National Committee on Uniform Traffic Control Devices

TECHNICAL COMMITTEE RECOMMENDATION

TECHNICAL COMMITTEE: Bicycle Technical Committee

TOPIC: Proposed Shared Lane Marking
Part 9 of the MUTCD

Diagram from San Francisco Shared Lane Marking study

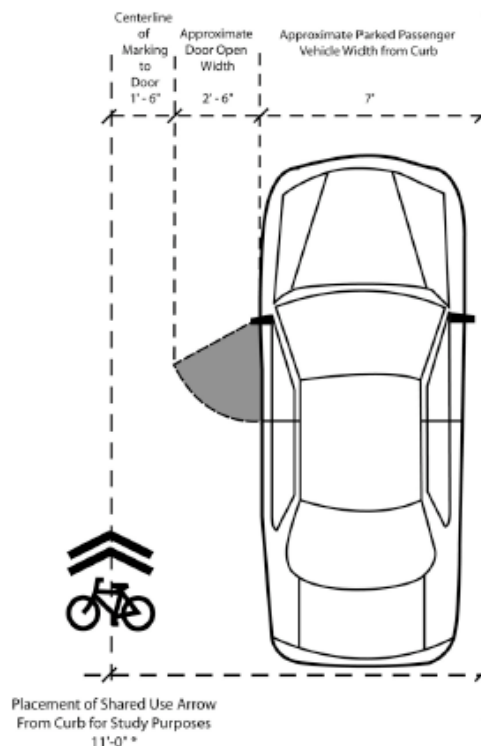
The Shared Lane Marking shown in Figure 9C-X may be used to assist bicyclists with positioning in a shared lane with on-street parallel parking and to alert road users to the location a bicyclist may occupy within the traveled way.

If used in a shared lane with on-street parallel parking, Shared Lane Markings shall be placed so that the centers of the markings are a minimum of 3.3 m (11 ft) from the curb face, or from the edge of pavement where there is no curb.

The Shared Lane Marking should not be placed on roadways with a speed limit above 55 km/h (35 mph).

When used, the Shared Lane Marking should be placed immediately after an intersection and spaced at intervals not greater than 75 m (250 ft) thereafter.
